TECHNICAL EVALUATION REPORT

REVIEW OF LICENSEES' RESOLUTION OF OUTSTANDING ISSUES FROM NRC EQUIPMENT ENVIRONMENTAL QUALIFICATION SAFETY EVALUATION REPORTS (F-11, B-60)

YANKEE ATOMIC ELECTRIC COMPANY
YANKEE ROWE NUCLEAR POWER PLANT

NRC DOCKET NO. 50-029

Figure A-4. Yankee Rowe Containment Temperature Profiles

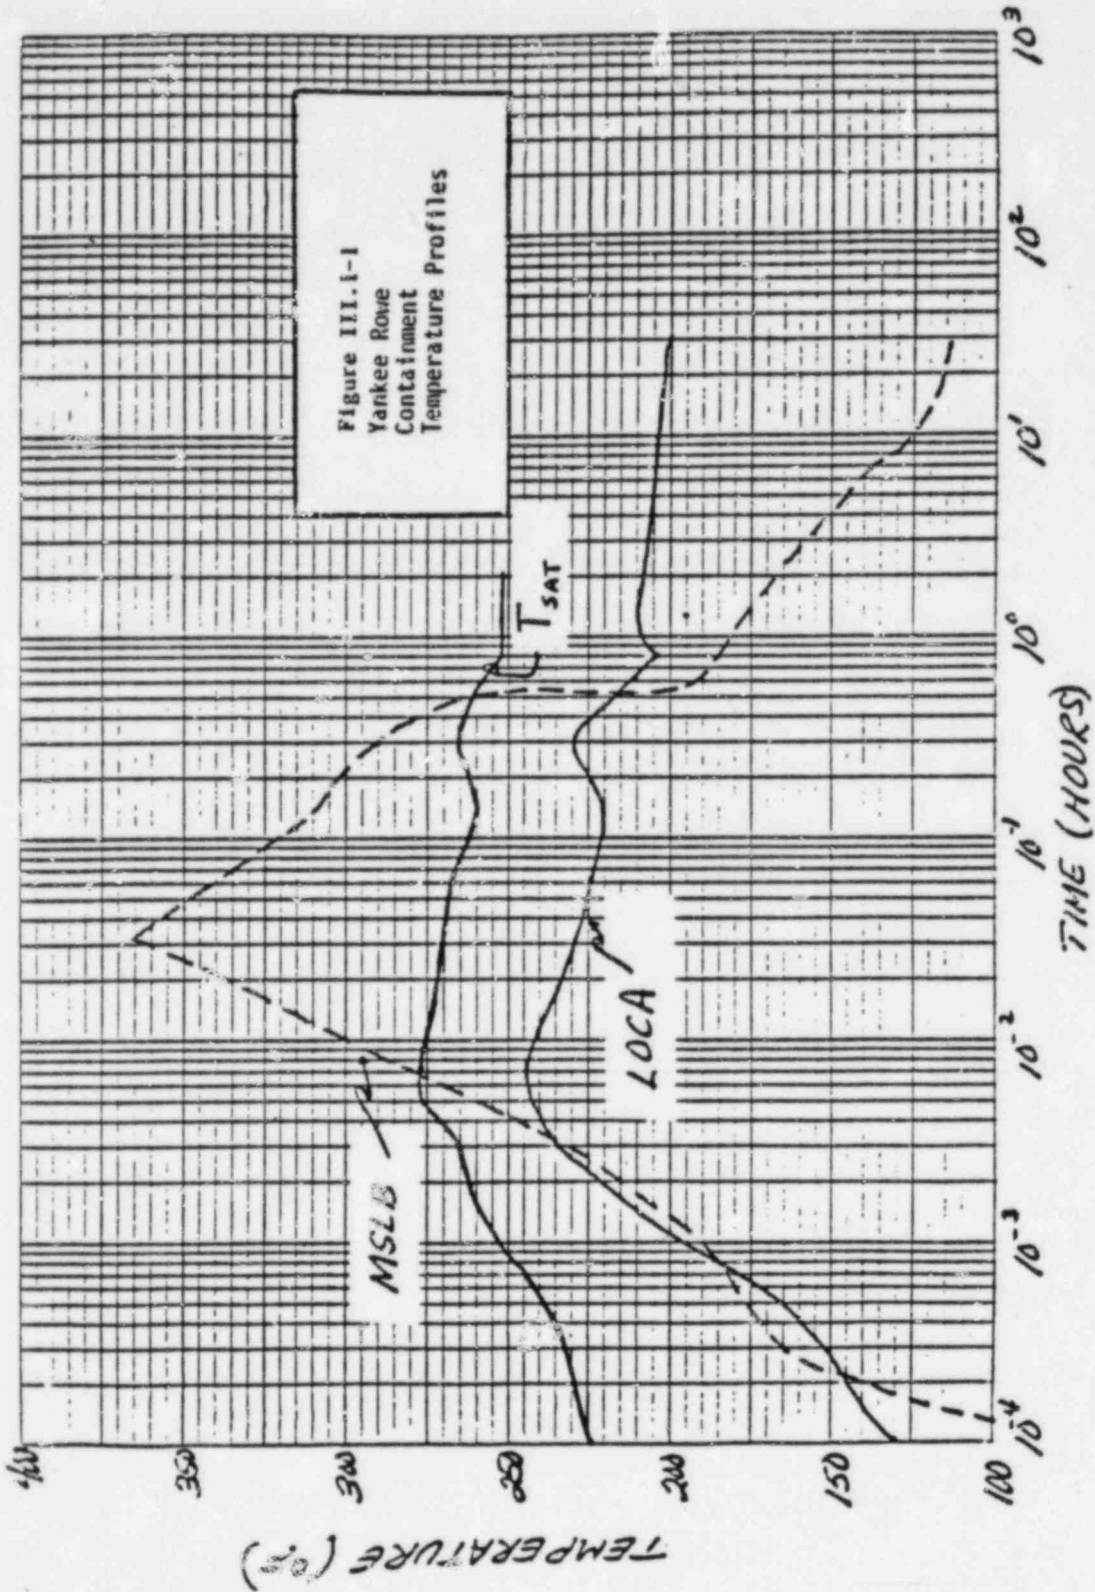
A saturation temperature profile has been plotted corresponding to the containment pressure profile. This profile has been added to Figure III.1-1 [A-4 of this report] and has been labeled T_{sat} . This curve was generated in response to Reference (b) to account for higher than average temperatures in the upper regions of the containment because of potential stratification.

The temperature profiles provided in the 90-day response [40] and reproduced as Figure A-4 were used in this technical evaluation report.

Figure A-5. Nomogram for Containment Volume and Reactor Power LOCA Dose Corrections

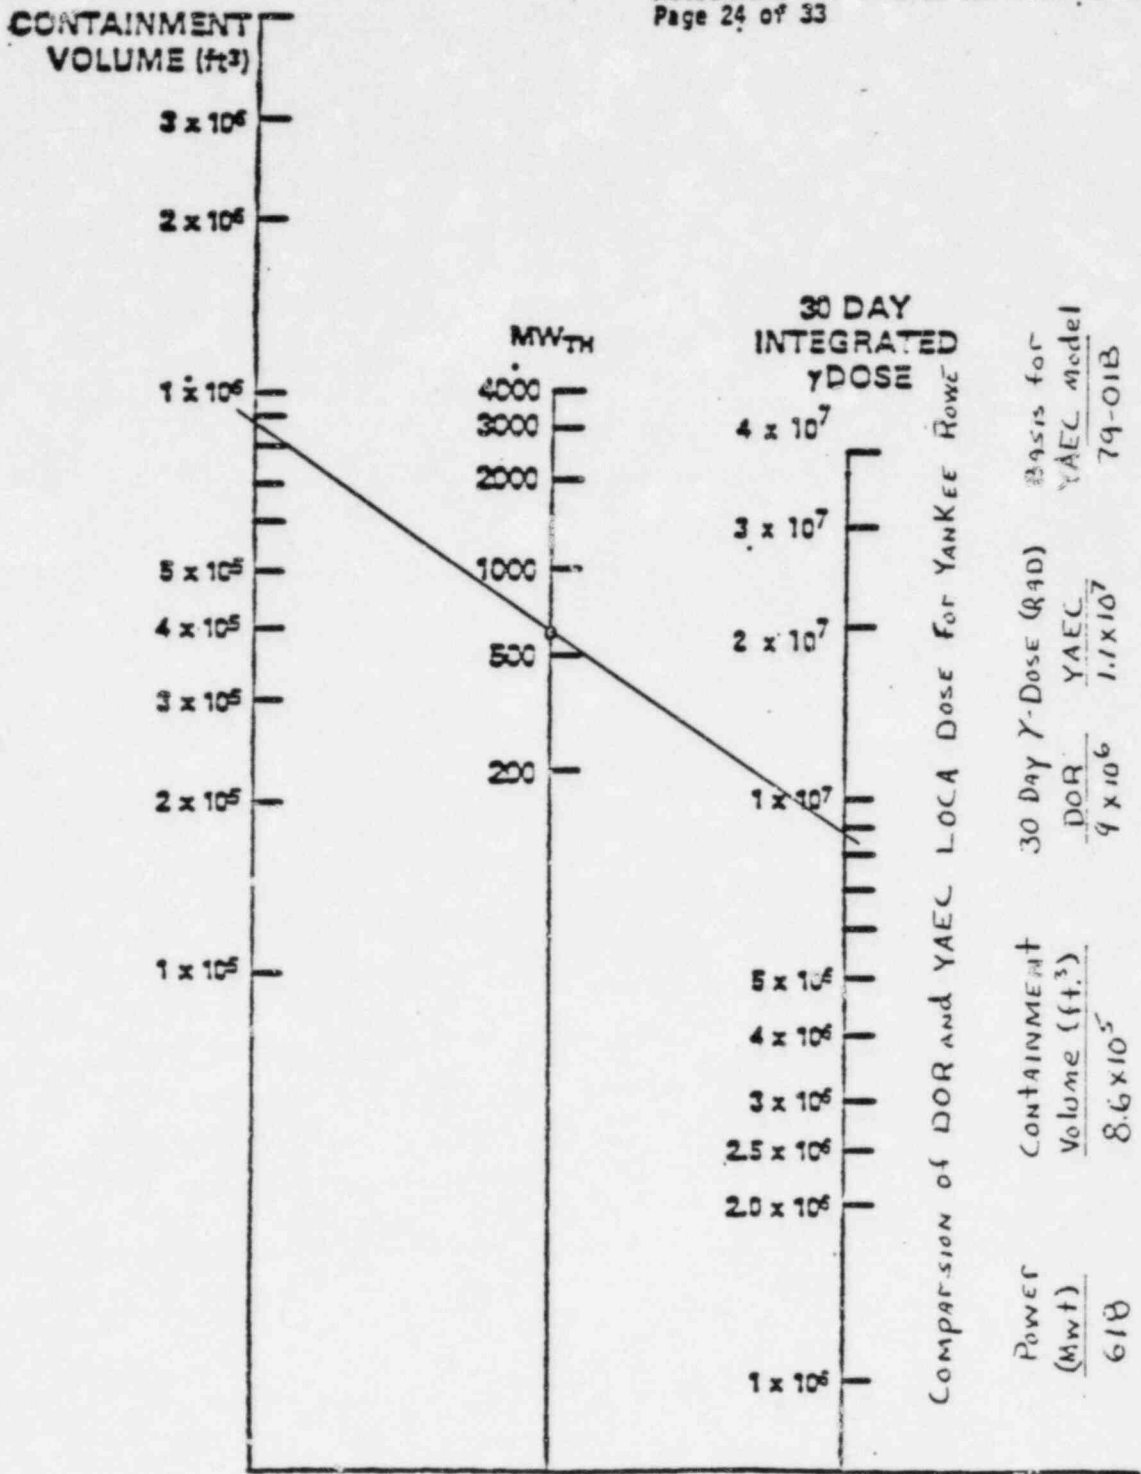
Figure 1 [Figure A-5 of this report] shows, by comparison, that the Yankee Gamma Dose Model is more conservative than the DOR Guidelines by 20%.
